# UNITED STATES PATENT AND TRADEMARK OFFICE

10/578,815

Paul Martyn Williams

<b>Office Action Summary</b>	<b>Application No.</b> 10/578,815	<b>Applicant(s)</b> WILLIAMS ET AL.	
	<b>Examiner</b> MARINA TIETJEN	<b>Art Unit</b> 3753

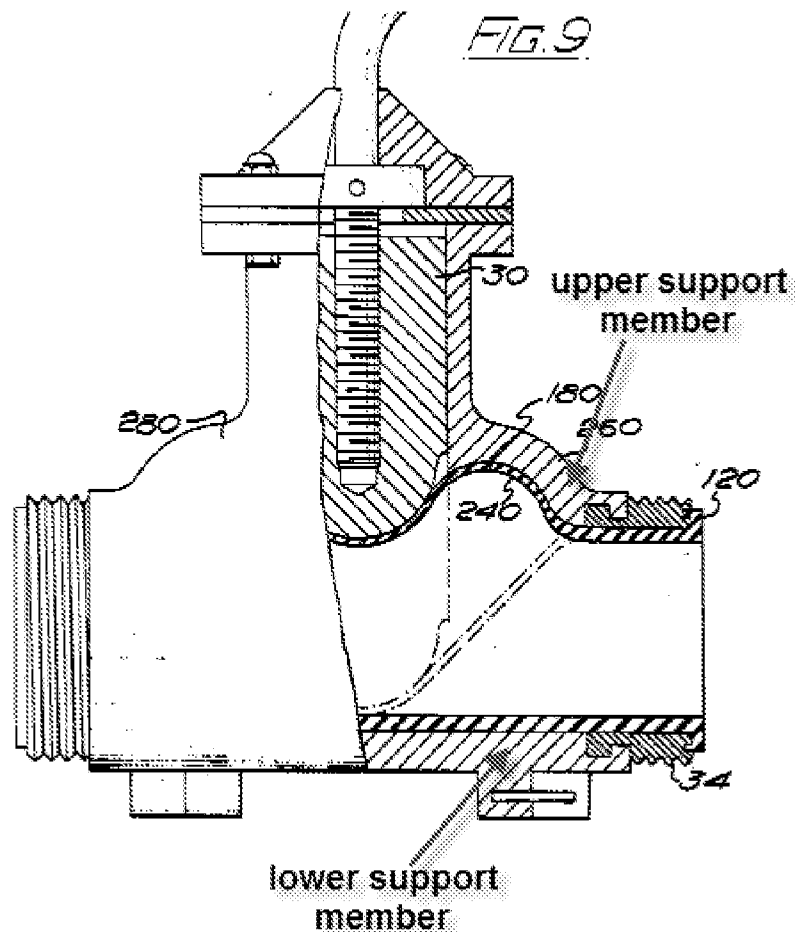
Regarding Claim 4, Summerfield discloses said housing 260, 280 is formed by an upper support member (see labeled Fig. 9 below) having a lower surface which engages an upper surface of said region of the valve body 200, and a lower support member (see labeled Fig. 9 below) having an upper surface which engages a lower surface of said region of the valve body 200, said upper and lower surfaces of said support members being of complementary shape to the respective upper and lower surfaces of the said region.

Regarding Claim 5, Summerfield discloses said support members define between each other a through opening through which said valve body extends (Fig. 9).

Regarding Claim 6, Summerfield discloses the region of the valve body 200 in which the seating area is defined has an upper wall and a lower wall, the upper wall being flexible and forming the diaphragm 180, and the lower surface 200 being rigid and its inner surface forming the valve seat (Fig. 9).
